File In/With: SI0327

Equipment Series 100 (Eco2) Packaged Rooftop Units: Models A, B, and C

Replacement of Condenser Fan Motors and Fan Blade Impellers

TABLE 2 - CORRECT PART NUMBERS FOR ORDERING

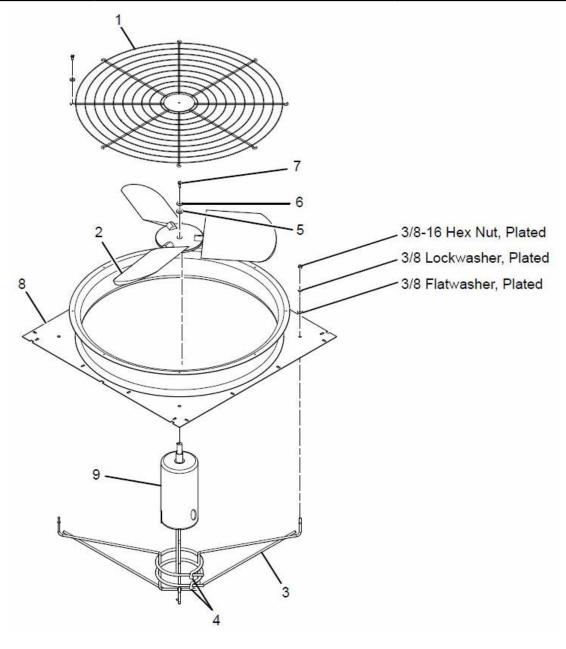
See the parts breakdown in *Table 2* on the next page for correct parts ordering. For proper replacement of a fan motor (item 9), you will also need to replace at a minimum items 2, 5, 6, and 7 depending on the voltage of the unit.

ITEM	DESCRIPTION	PART NUMBER
1	GUARD, WIRE, 900MM DIA.	026-35605-000
2	FAN, IMPELLER, 900MM (35.20")	026-41594-000
3	SUPPORT, COND MOTOR, WIRE FRAME	026-36366-000
4	MOTOR SUPPORT RING	026-36367-000
5	SPACER, FAN, MOTOR	075-40484-000
6	SPACER, FAN, MOTOR	075-29007-000
7	SCREW, HC, M8 1.25LG-6G	021-18494-000
8	ORIFICE, CONDENSER, 36.0	026-36384-000
9	FAN MOTOR, 200V (17)	024-27322-103
	FAN MOTOR, 230V (28)	024-27322-106
	FAN MOTOR, 460V (46)	024-27322-107
	FAN MOTOR, 575 (58)	024-27322-102
